SJA ref: SJA wp 14023-01

LPA ref: 19 01788 AS

### **Without Prejudice Statement**

### **Response to Ashford Borough Council's Landscape Officer Comments dated 17<sup>th</sup> June 2020**

**Figure 1 – illustrating the comparison between the morphed buffer zone we have recommended, and the circular buffer required by the landscape officer**

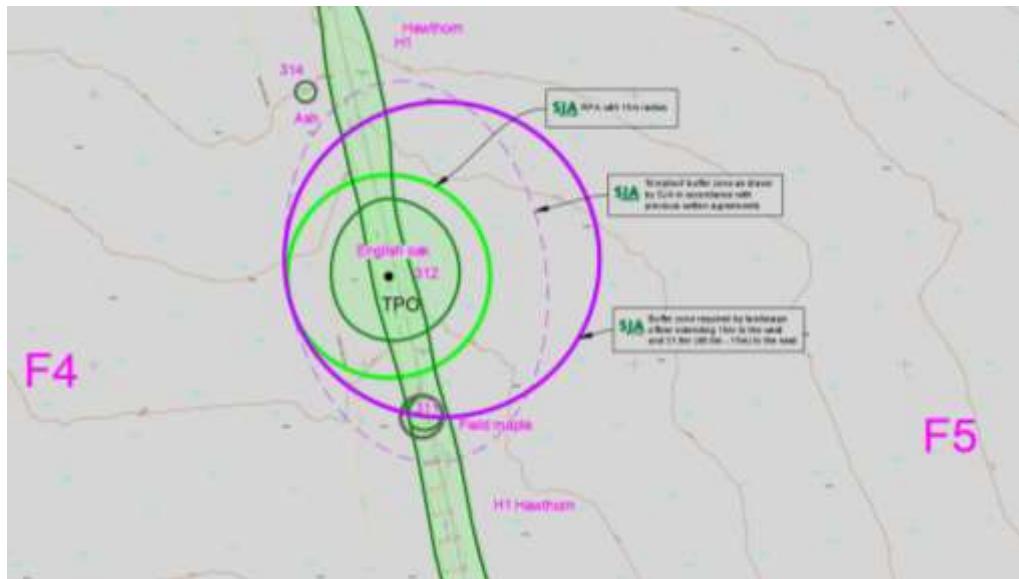
b. The changes now sought do not allow for any ‘morphing’<sup>1</sup> of the veteran tree’s buffer zone. The Landscape Officer clearly states in his most recent comments that ‘*the buffer zone may be morphed or offset*’ but the equation on which he has based the sketch in his comments results in a circle, thus making the morphing of the buffer zone impossible. Therefore, we have ended up with an offset, circular buffer zone, as illustrated below.
